**PLANNING COMMISSION REPORT
Regular Agenda -Public Hearing Item**

**ITEM NO. 13 PRELIMINARY DEVELOPMENT PLAN/SMARTCODE COMMUNITY
INFILL PLAN REDEVELOPMENT PROJECT 1401 W. 23RD STREET (SLD)**

**ITEM NO. 13C PRELIMINARY DEVELOPMENT PLAN; 1401 W 23RD ST & 1300 W 24TH
ST (SLD)**

PDP-18-00537¹: Consider a preliminary development plan (Community Infill Plan - SmartCode) for 23rd Street Mixed Use development including 119 residential units for a density of 27 dwelling units per acre and 8,811 square feet of retail space on property located at 1401 W. 23rd St & 1300 W. 24th St. Submitted by Opus Development Company LLC, for George B. Leinmiller and Marlene J. Leinmiller, property owners of record.

Figure 1: Recommended pedestrian connection

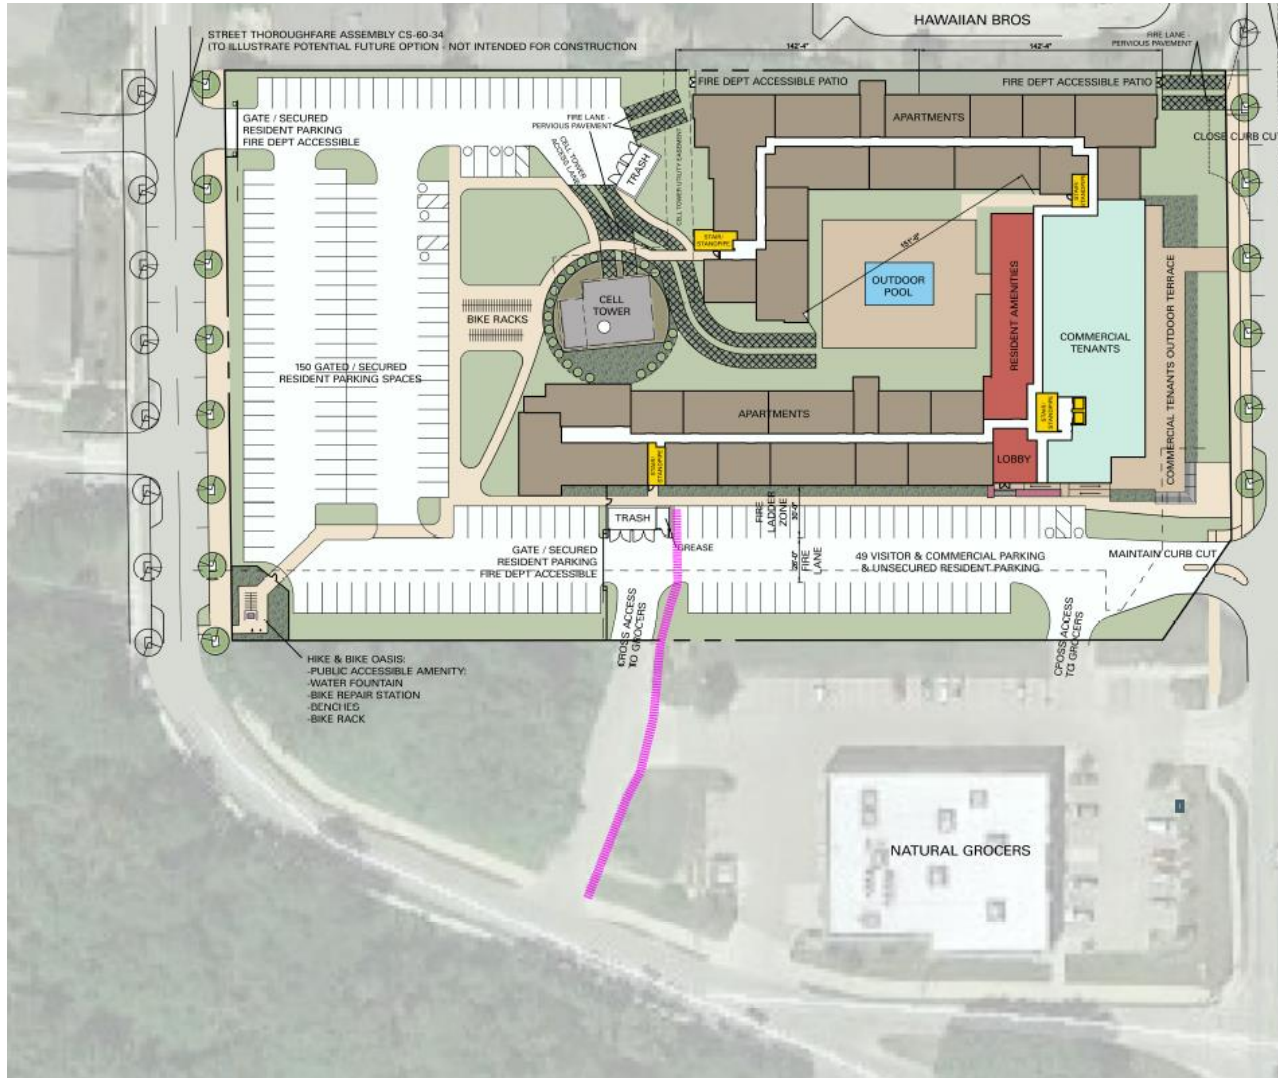
The project is located along a designated multi-use path and has a proposed connection to a public park. The multi-use path provides a key non-motorized mode of transportation to the development. The plan, as proposed does not include connectivity from W. 24th Street to the commercial area or connectivity between the development and the transit stop. The image below shows a connection that would provide improved pedestrian connection between the development, the multi-use path, transit stop, and the community.

The connection is recommended along the north side of the drive to provide the most direct pedestrian connection. This shared driveway is located within public right-of-way. It is an existing drive that will be maintained and serves the existing development.

1. Revise plan to show pedestrian sidewalk connection to the northbound Naismith Drive transit stop.

Staff Finding – Infrastructure and system capacity are conceptually available to the development area. Certain public improvements are required for the project including public sidewalk design and pedestrian connections to the northbound Naismith Drive transit stop.
